# Video Products Technical Bulletin 30-2006-072

SUBJECT: REUSE PARTS WHEN REPLACING THE A BOARD

MODEL: PVM-2950Q

Figure 1

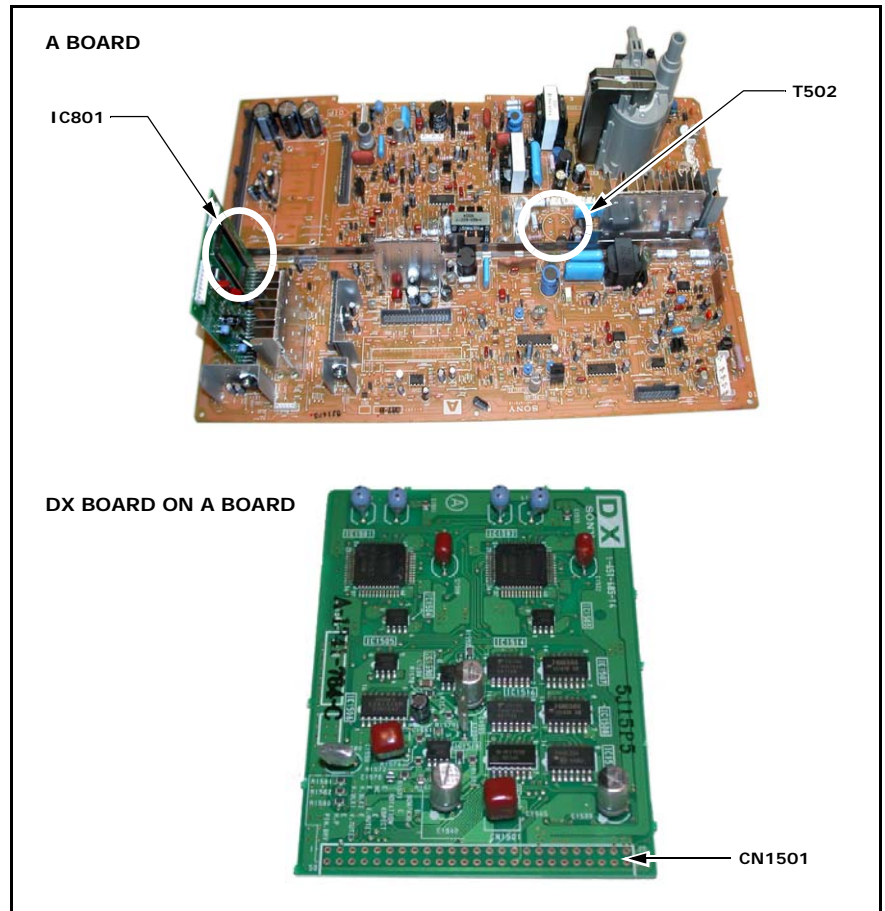
When you replace the A board (A-1297-387-B), remove the following parts from the former board and install them on the new board.

Ref. No.	Description	Part No.
T502	Horizontal linearity transformer	1-460-199-11
CN1501	50P connector pin (for DX board on A board)	1-573-965-21
IC801	IC HD6433257-A10P	8-759-358-88

The new A board does not contain the parts, and the parts are no longer available. (See Figure 1.)
